**3GPP TSG CN Plenary Meeting #21**  
**17<sup>th</sup> – 19<sup>th</sup> September 2003 Frankfurt, GERMANY.**

**NP-030380**

**Source:** TSG CN WG4  
**Title:** Corrections on mobile OoBTC  
**Agenda item:** 7.7  
**Document for:** APPROVAL

⌘ **23.153 CR 062** ⌘ rev **1** ⌘ Current version: **4.8.0** ⌘

**Figure 5.8.3-4/1: Successful Codec Modification including IuFP**

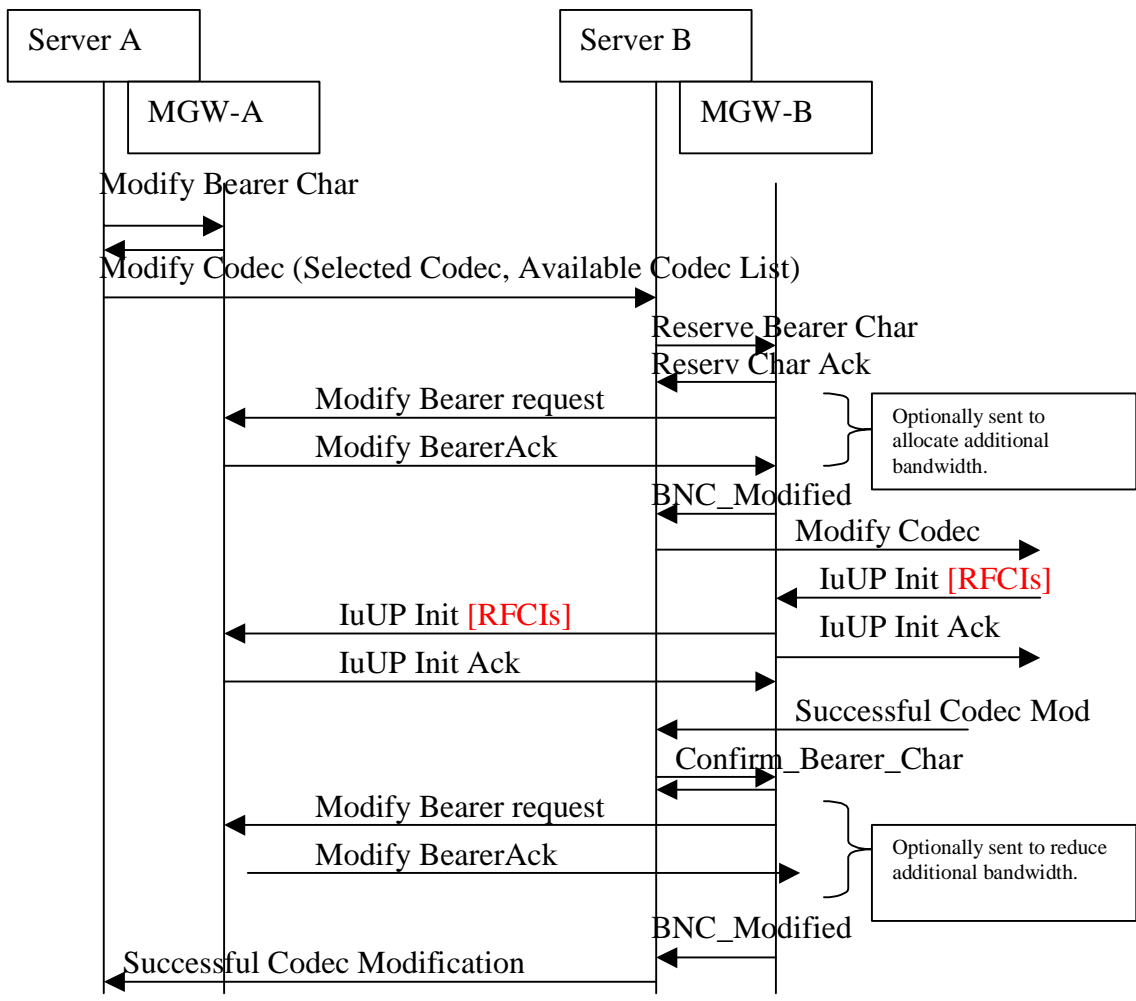
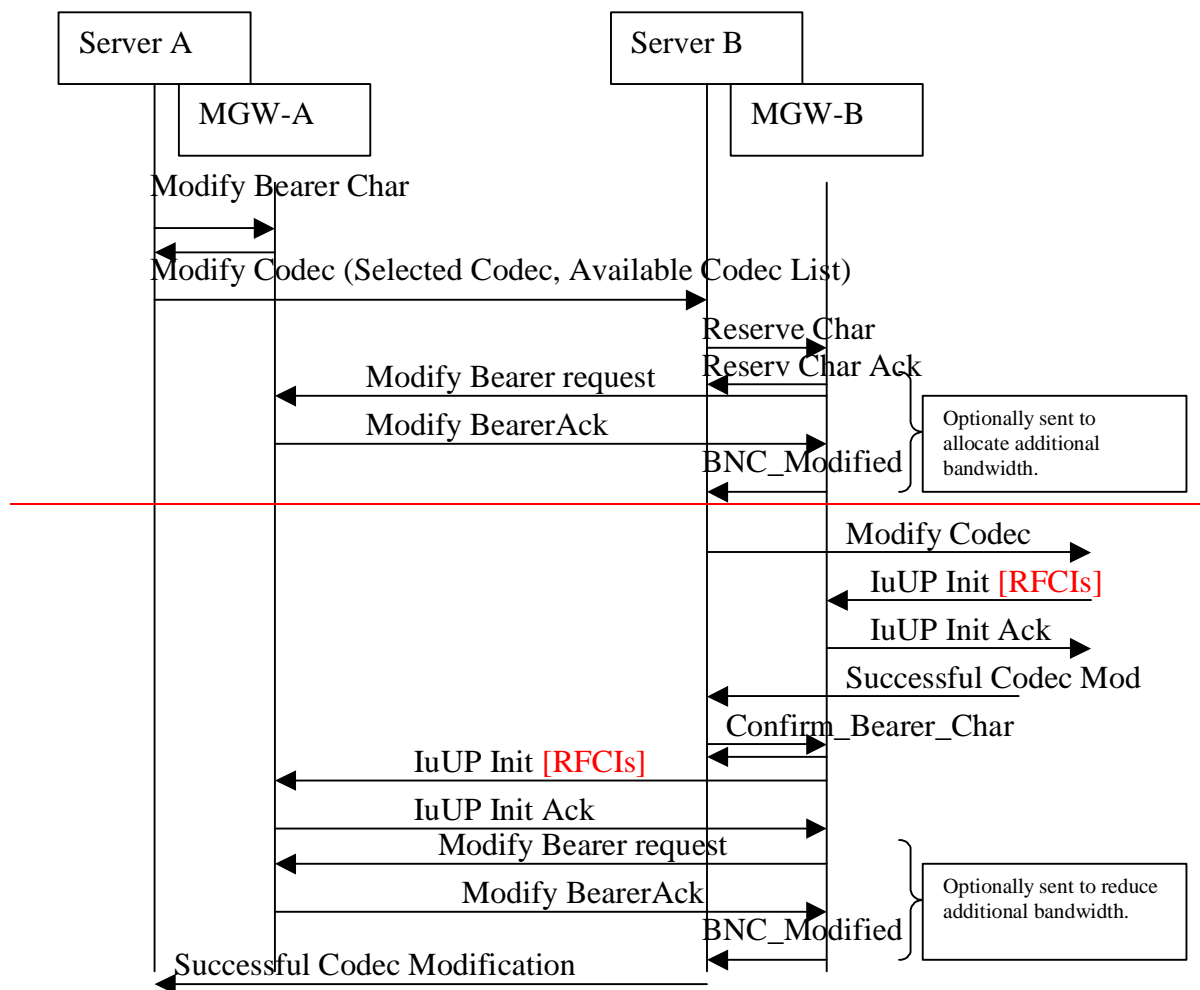
**Reason for change:** ⌘ 1. Errors in Figures 5.8.4/1, which contradict Figures 5.8.4/2, 5.8.5/1 and 5.8.5/2 and the text in this specification with respect to:

BNC Modified message is required to be sent

UP Initialisation arriving before Confirm Bearer Characteristics should be passed immediately to avoid interruption in speech.

**Summary of change:** ⌘ 1. Corrections in Figure 5.8.4/1

BNC Modified message is not optional

Confirm Bearer Characteristics does not trigger UP Initialisation

**Figure 5.8.4/2: Mid Call Codec Negotiation Call Sequence. Call Flow Part 1**

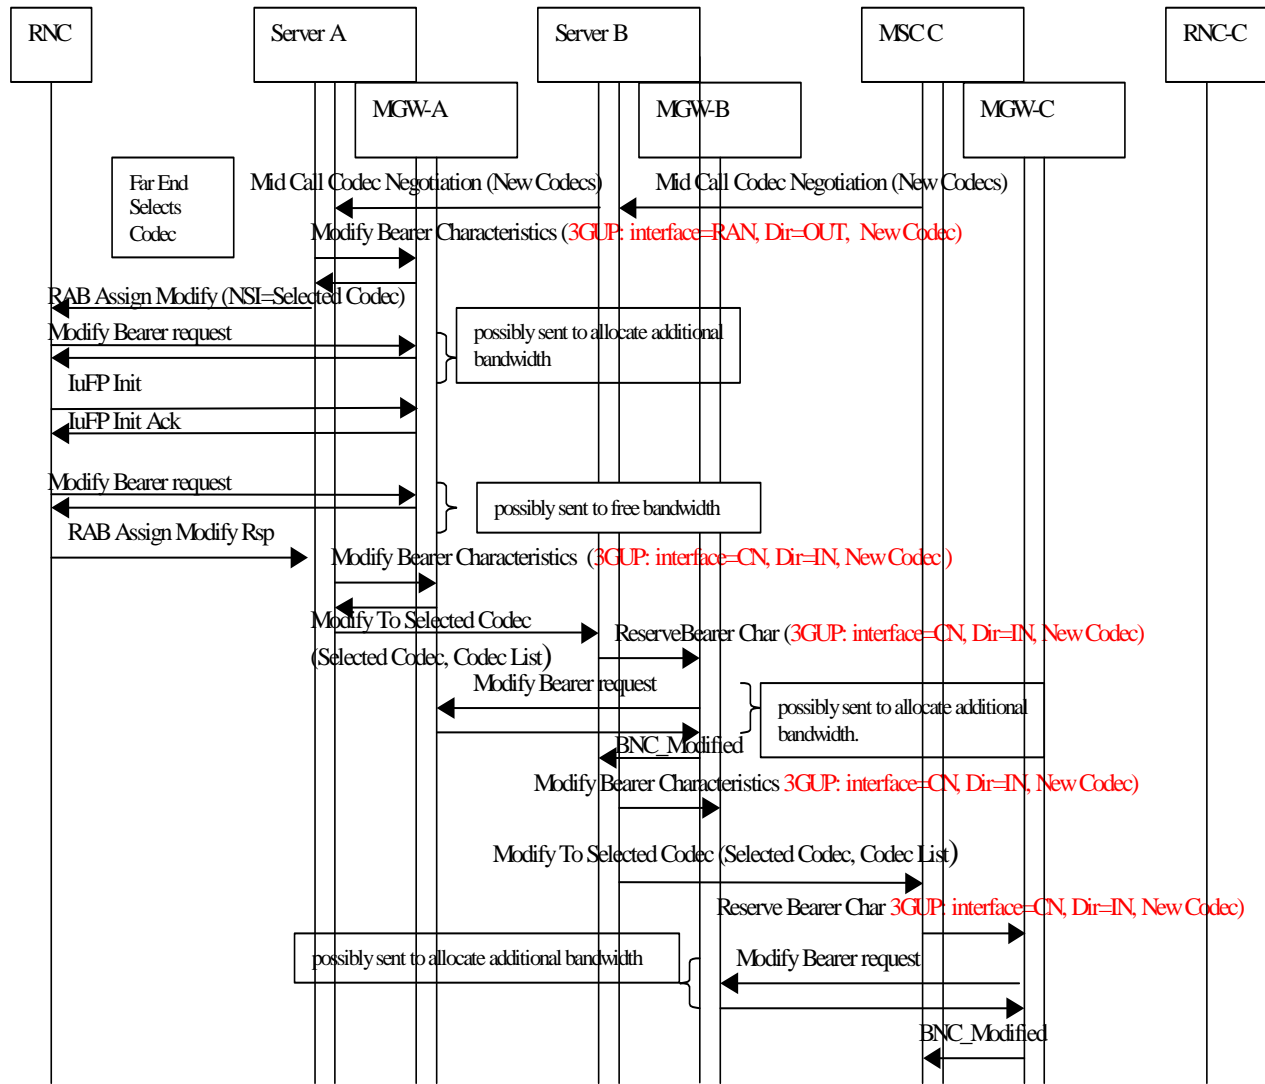
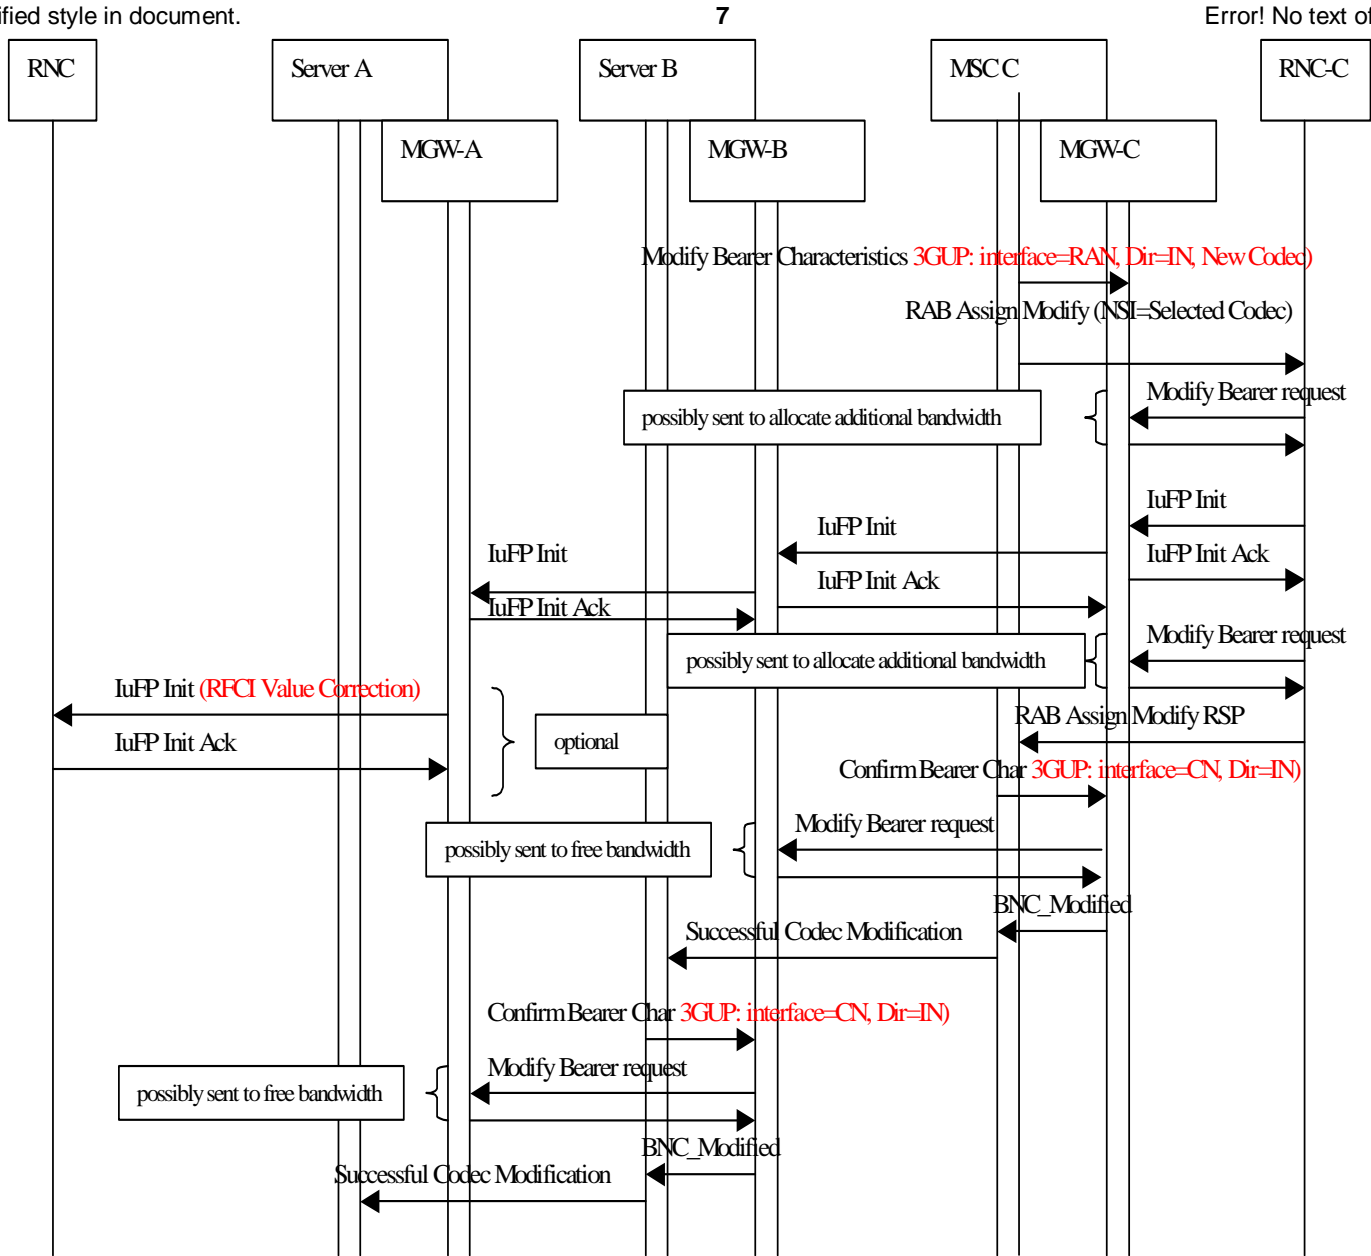
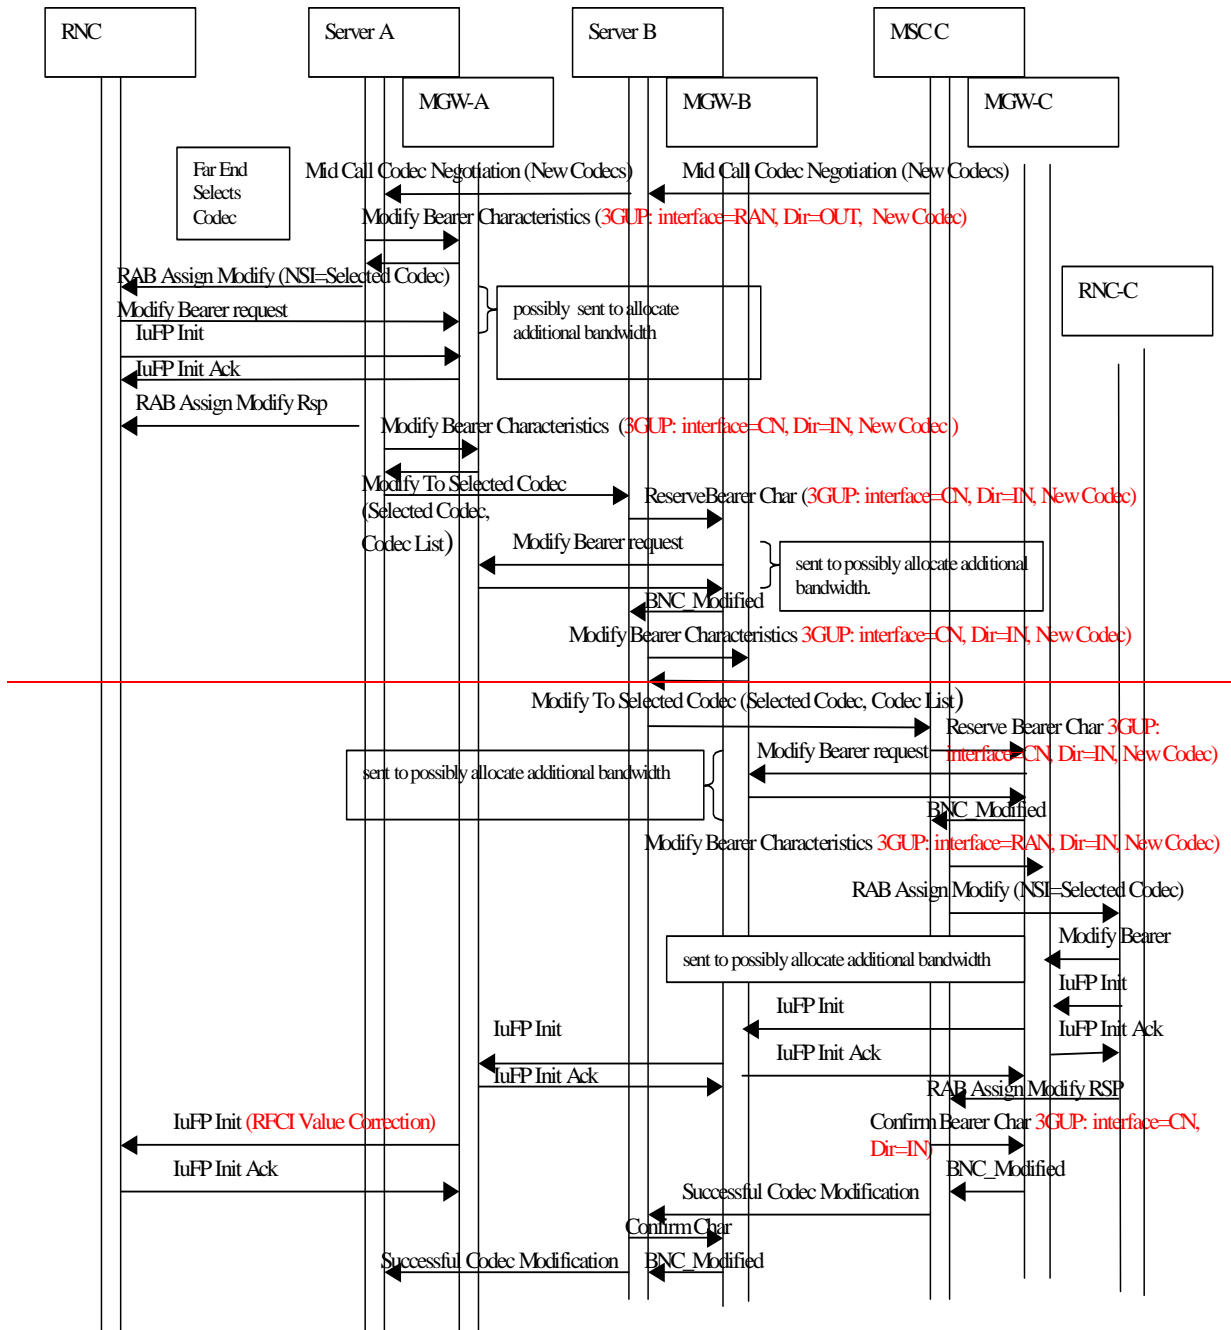
2. Errors in Figures 5.8.4/2:

Optional Bearer Modification to reduce bandwidth omitted (allowed according to BICC and Figure 5.8.1/2)

Rab Assign Modify Response in wrong direction

2. Corrections in Figure 5.8.4/2

Direction of Rab Assign Modify Response turned around

Optional Bearer Modification to reduce bandwidth added

Figure Split in two for better readability

**Figure5.8.5/2: Call Sequence for Unsuccessful Modification. [Call Flow Part 1](#)**

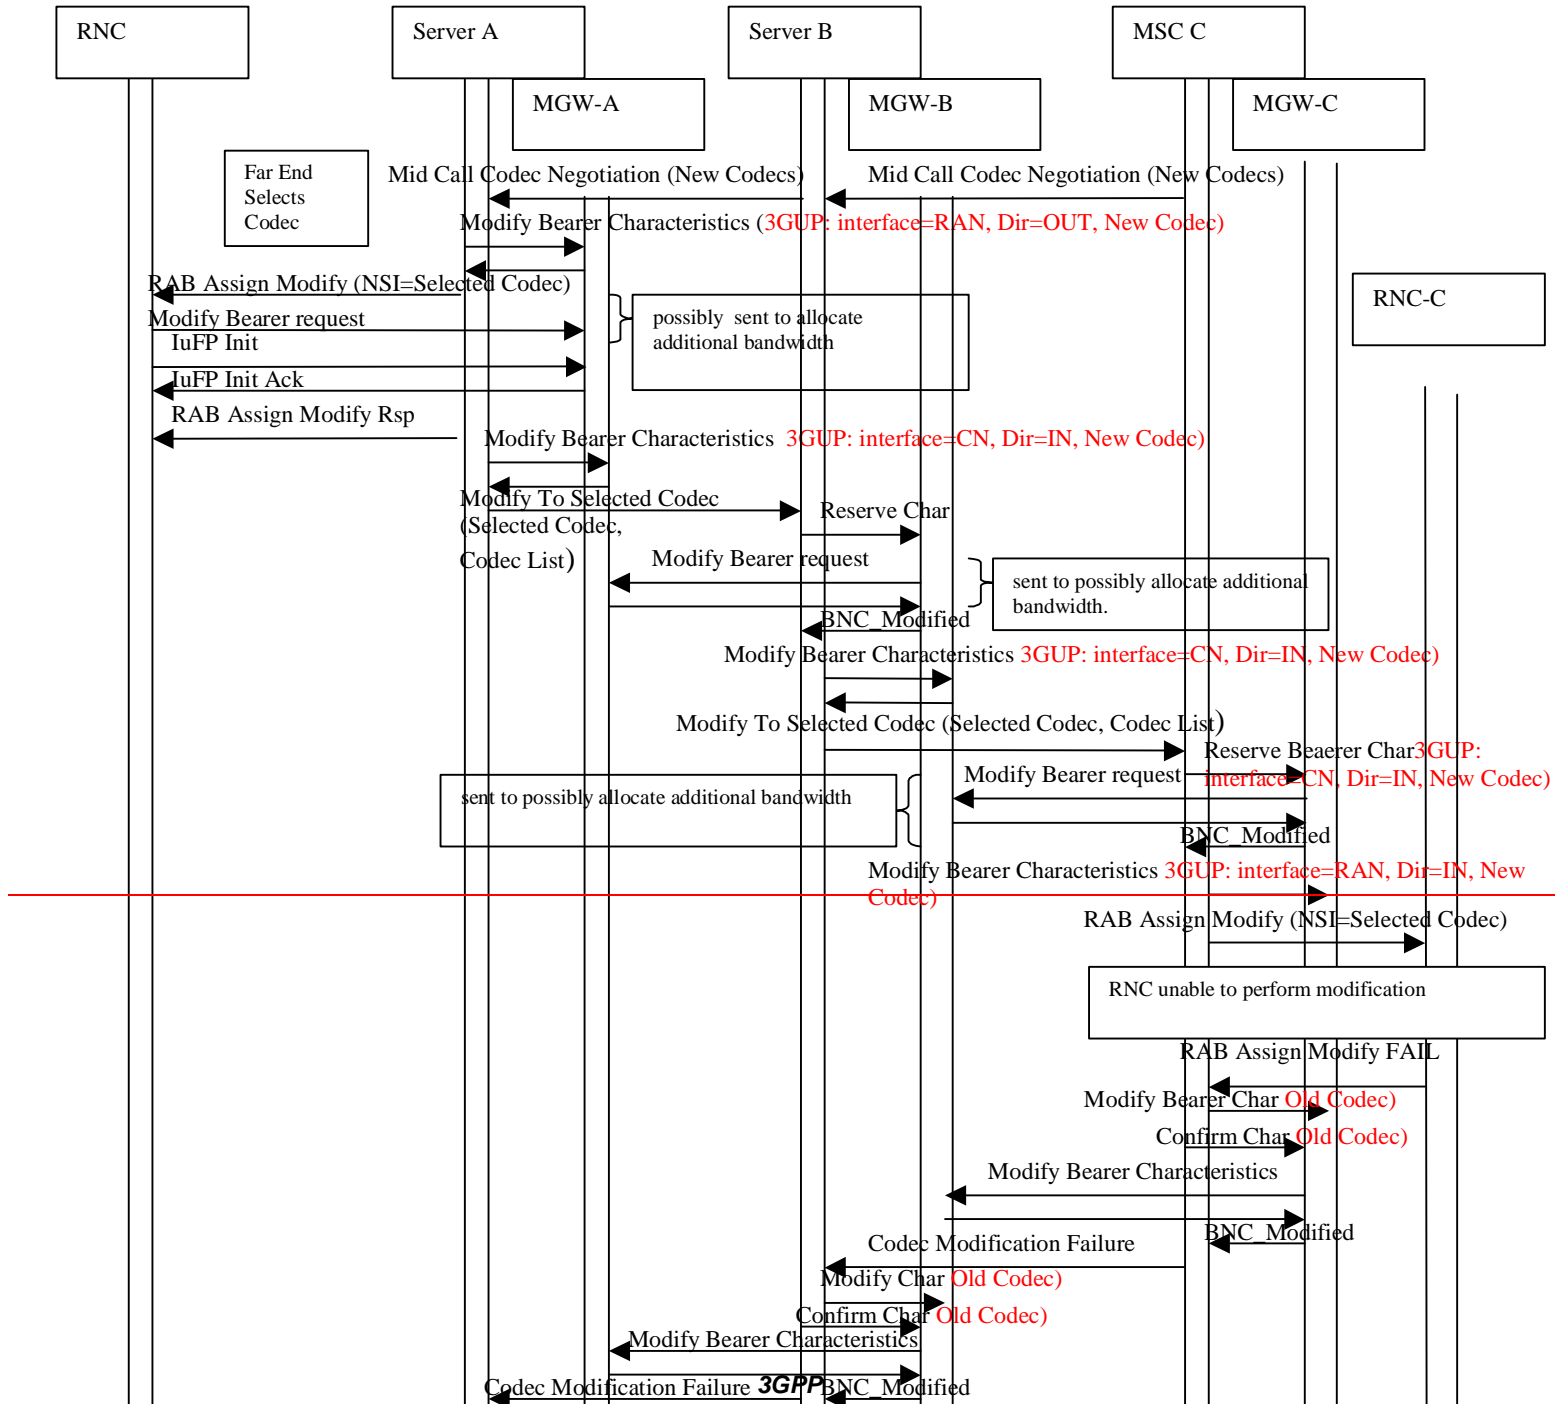
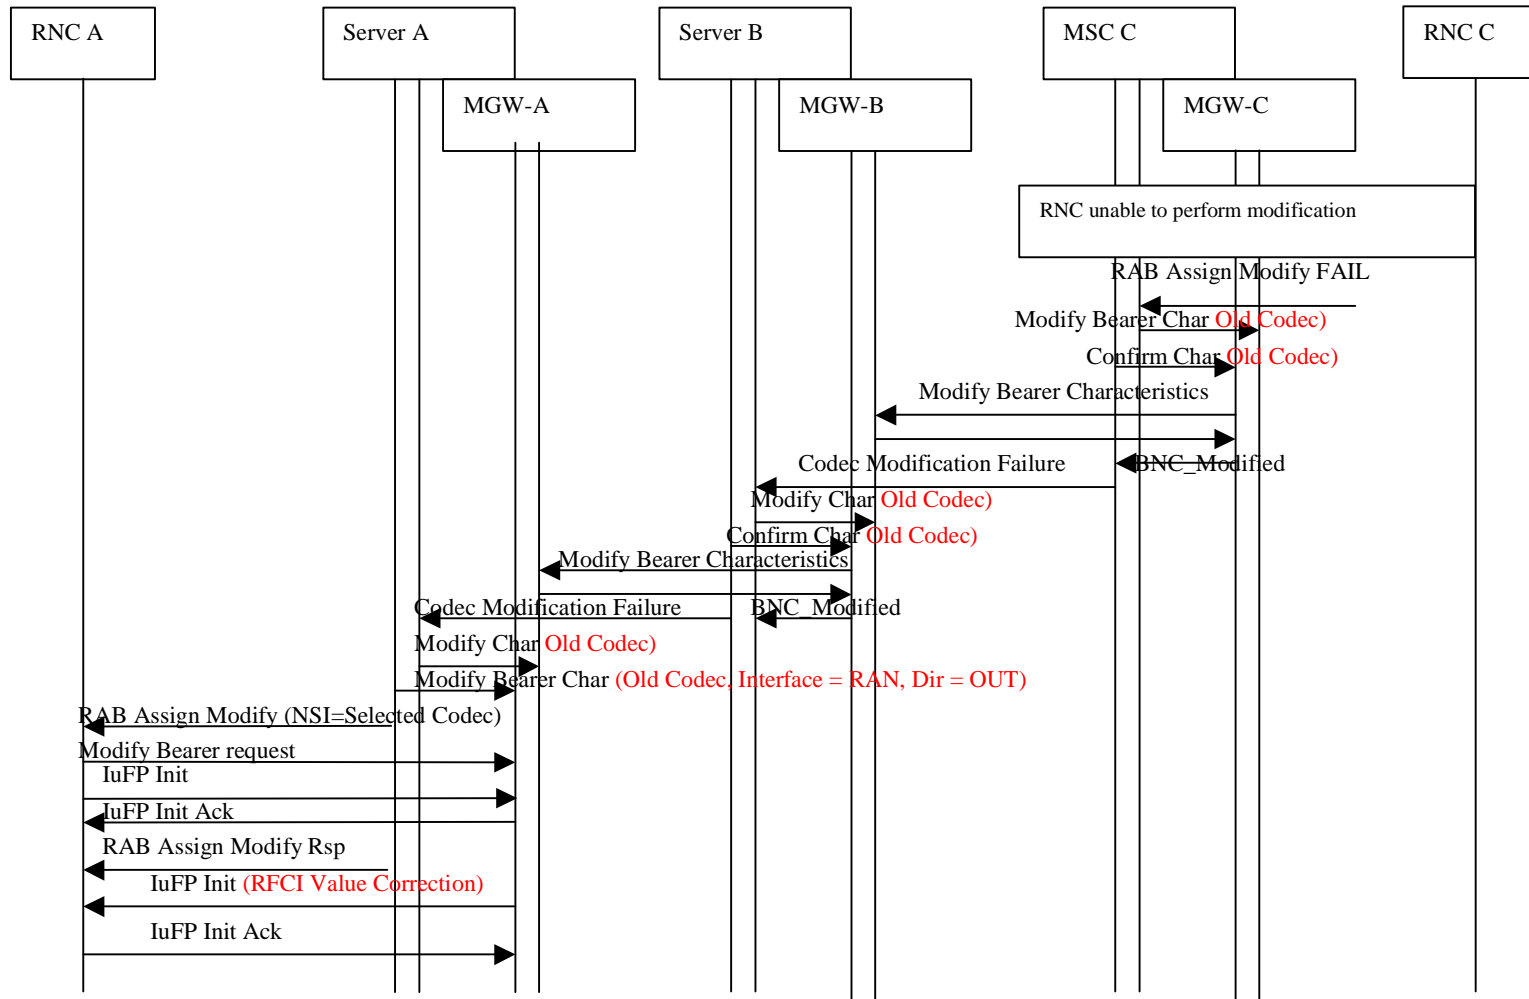
3. Figure 5.8.5/2 does not fit on one page and will not be printed completely

3. Figure 5.8.5/2 is split in two
